ENGINEERING CHANGE NOTICE

SFP-70D / SFP-70D2 シリーズ用モーターの変更及び、それに伴う研磨機への変更  
Change of motor for SFP-70D / SFP-70D2 series and change to polishers due to this change

Reference: Photos of the spacer and external view of the polishing machine after installation of the spacer for repair

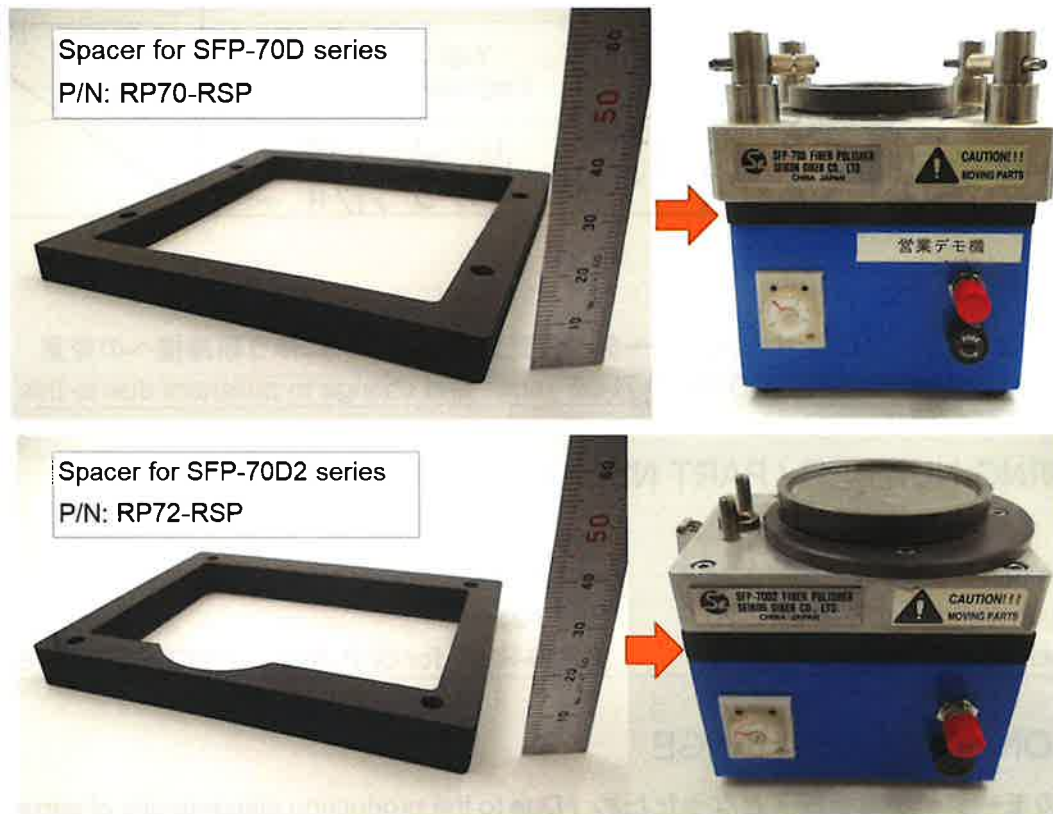
新型のモーターは公転用・自転用共に全長(L 寸法)が長くなる為、現行の SFP-70D 及び、SFP-70D2 に新型モーターを搭載する際には、必ず上記のスペーサーを同時購入頂き装着願います。スペーサーの装着により、ハウジング部が約 10mm 嵩上げされます。また、弊社でのモーター交換を伴う修理の際にも、同スペーサーが装着されます(次項参照)。

Since the newer motor is longer than the current motor in the "L" dimension, please be sure to purchase and install the above spacer when installing the newer motor on the current SFP-70D or SFP-70D2. The spacer raises the height of the housing portion by approx. 10mm. The same spacer is also installed during repairs that involve motor replacement (refer next page).
